#### **Addendum 128 – UN Regulation No. 129**

#### **Revision 1 - Amendment 8**

Supplement 7 to the 01 series of amendments – Date of entry into force: 3 January 2021

#### **Uniform provisions concerning the approval of Enhanced Child Restraint Systems used on board of motor vehicles (ECRS)**

Figure 2  
ECRS Measurement Device - Side and Front View of the measuring device

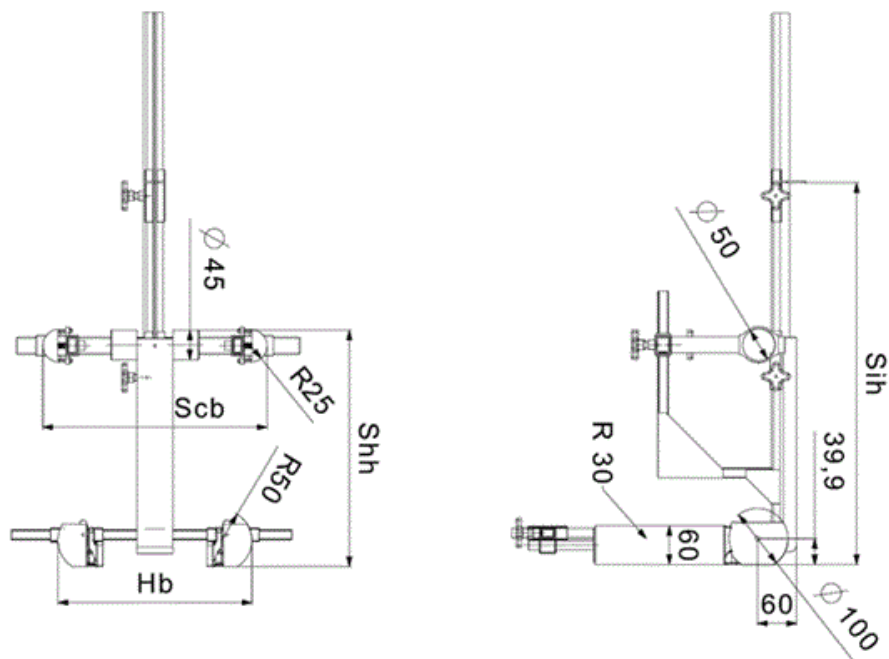
Annex 18., amend to read:

For integral or non-integral ECRS the device shown in Annex 18, Figure 2 shall be used.

The mass of the devices described in Figure 2 and Figure 3 shall be 10 kg +/- 1 kg.

All measurements shall be taken with the device base in contact with the seat pan of the ECRS and the device backrest in contact with the backrest of the ECRS. All lateral dimensions shall be measured under a contact force of 50 N with the devices described in Figure 2 and Figure 3 of this annex.

Figure 3  
Side and Front View of the measuring device for measurements applicable to Enhanced Child Restraint Systems that feature an impact shield

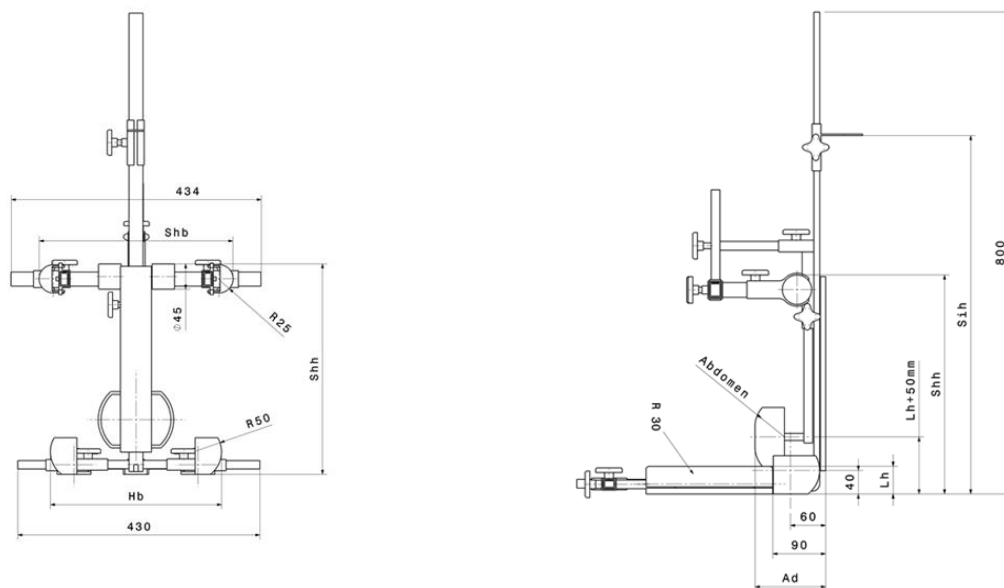
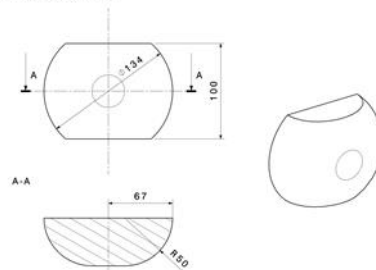
For ECRS with an impact shield the device shown in Annex 18, Figure 3 shall be used.
